REMARKS

The instant application is directed to a method of manufacturing a distributed analog phase shifter, the method comprising, (a) depositing a ferroelectric film on a substrate, (b) etching the ferroelectric film to form ferroelectric patterns, (c) depositing a metal layer on the substrate on which the ferroelectric patterns have been formed; and (d) forming a coplanar waveguide, first electrodes, a ground line, and second electrodes by etching the metal layer covering the ferroelectric patterns, wherein the first electrodes and the second electrodes are formed such that portions of the first electrodes and second electrodes overlap with the ferroelectric pattern, respectively.

MARKED-UP SHEET

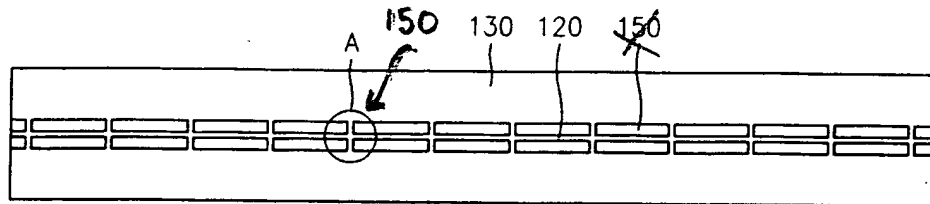
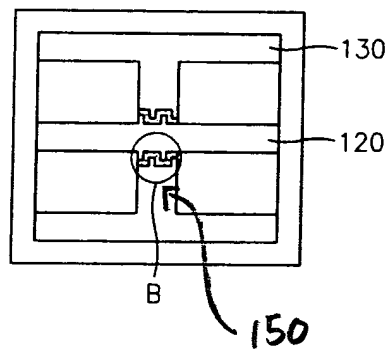
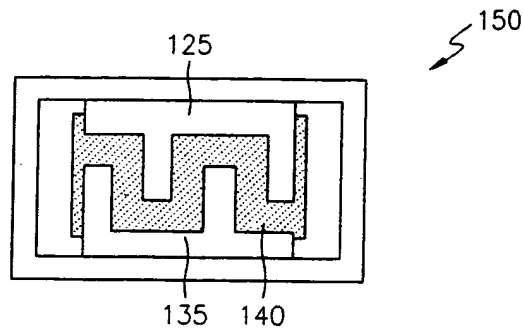
In the outstanding Action, the Examiner objects to the drawings for failing to comply with 37 CFR 1.84(p)(4) alleging reference character “150” is used to designate the indigitated capacitor (“IDC”) shown in Figure 4C whereas in Figure 4A “150” does not point to the IDC of Figure 4C. The Examiner further alleges in Figure 4A, the reference number “150” points to a region outside of Figure 4B. Applicants respectfully submit herewith corrected drawing sheets in compliance with 37 CFR 1.121(d) and marked up drawings in which reference number “150” has been corrected to refer to the correct grouping of components. In view of the foregoing, Applicants respectfully request reconsideration and withdrawal of the objection to the drawings on this basis.
